U.S. Department of the Interior
BUREAU OF LAND MANAGEMENT

Well Name: RAE'S CREEK 25 36 22 FED COM	Well Location: T25S / R36E / SEC 22 / SWSE / 32.1091419 / -103.2501764	County or Parish/State: LEA / NM
Well Number: 095H	Type of Well: OIL WELL	Allottee or Tribe Name:
Lease Number: NMNM136231	Unit or CA Name:	Unit or CA Number:
US Well Number:	Operator: MATADOR PRODUCTION COMPANY

Notice of Intent

Sundry ID: 2885202**Type of Submission:** Notice of Intent**Type of Action:** APD Change**Date Sundry Submitted:** 12/04/2025**Time Sundry Submitted:** 08:55**Date proposed operation will begin:** 12/04/2025

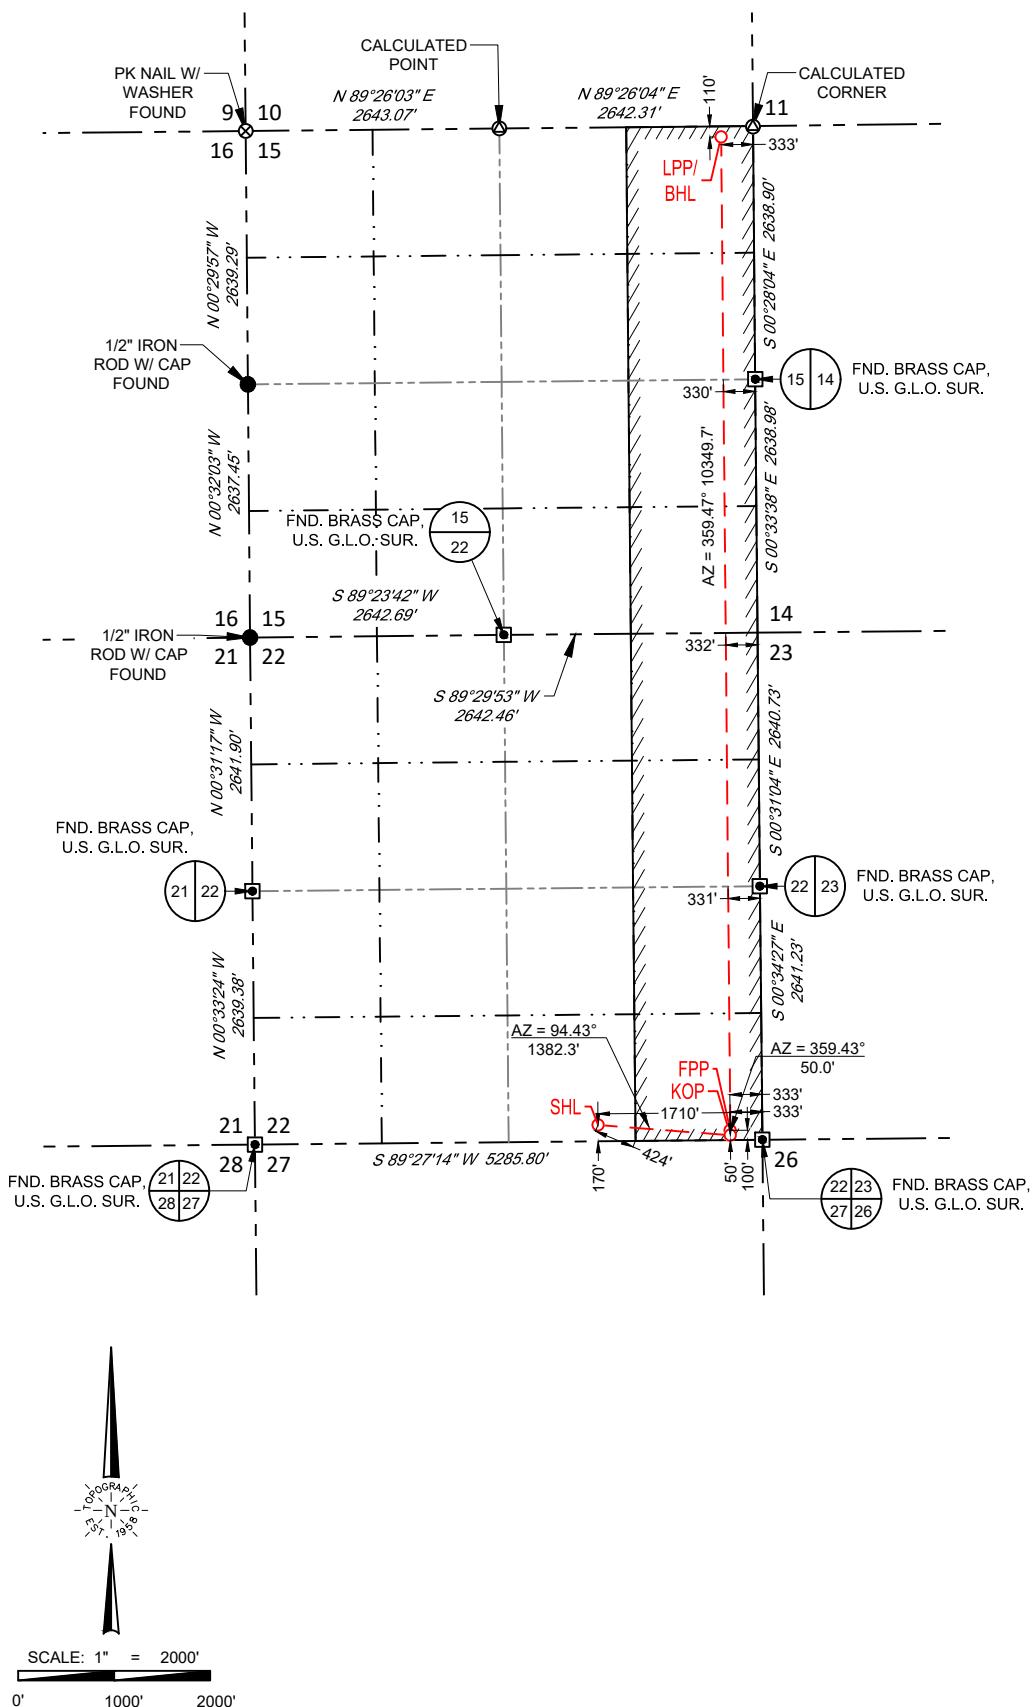
Procedure Description: BLM Bond# NMB001079; Surety Bond# RLB0015172 Matador requests to skid over to spud the well using a new surface hole location going FROM 200' FSL & 1710' FEL S22-25S-36E TO 170' FSL & 1710'FEL S22-25S-36E, as reflected in this sundry, due to the incorrect size conductor being set in the original location. As reflected in the attached, the completed lateral and bottom hole location for the well remains the same. We understand the NMOCD will then assign the replacement well under this sundry a new API number, leaving the original location with its same API number. The original well will be named RAES CREEK 25 36 22 FEDERAL COM 095Y (API 30-025-54321). The well we will skid to spud will be named RAES CREEK 25 36 22 FEDERAL COM 095H and will be assigned a new API # from NMOCD. Please see the attached supporting documents. Sundry# 2885198 has been submitted to address P&A.

- Matador requests to change the surface hole location from 200' FSL to 170' FSL as per the attached C-102. Directional plans and drilling plan has been updated accordingly.

Raes Creek Fed Com #095H – Plug Back Design

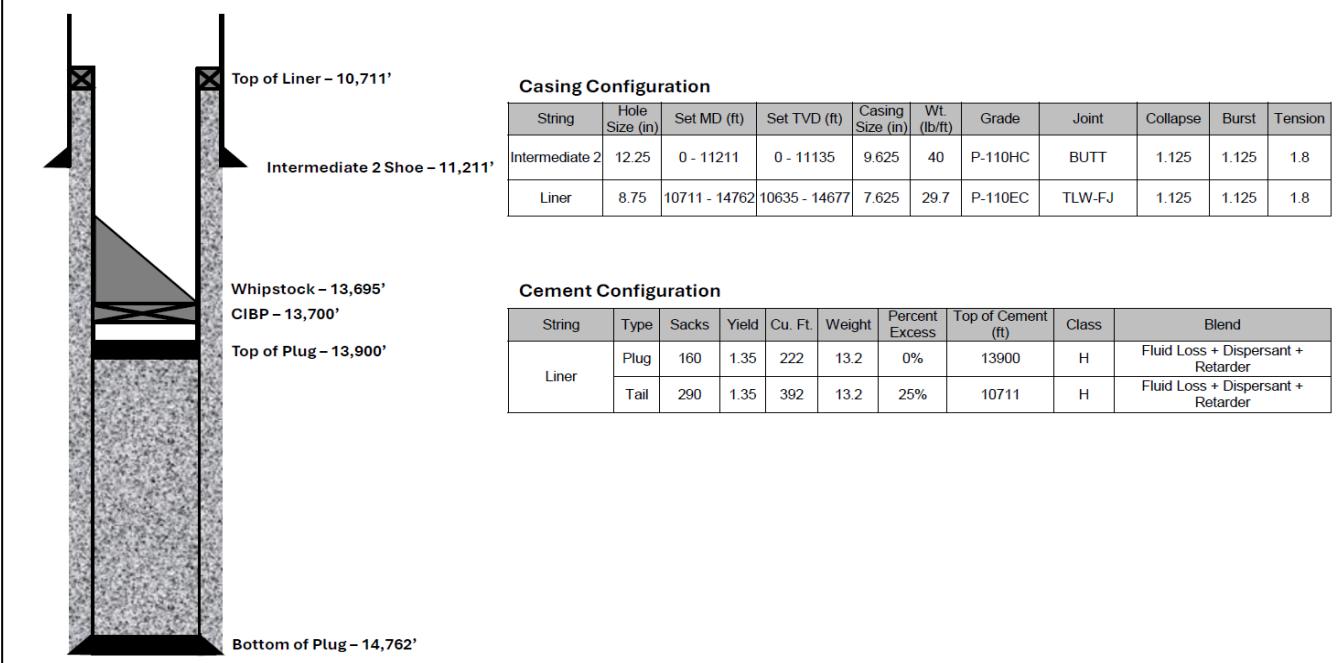
The pilot hole plugging procedure is approved as written, with the modification that more cement will be needed to have the inside plug from 14,762 ft. to 13,900 ft. Please adjust the cement volume accordingly. Note plug tops on subsequent drilling report. The BLM is to be contacted 24 hours prior to the commencement of any plugging operations (575-689-5981 Lea County) and when tagging the plugs.

The 8.75" pilot hole will be drilled to ~14,772' MD and then cased and cemented. A cement plug will be put in place inside the liner from ~14,762' to ~13,900', then a cased hole whipstock will be set at ~13,700' MD to mill a window in the casing for the 6.75" production section.
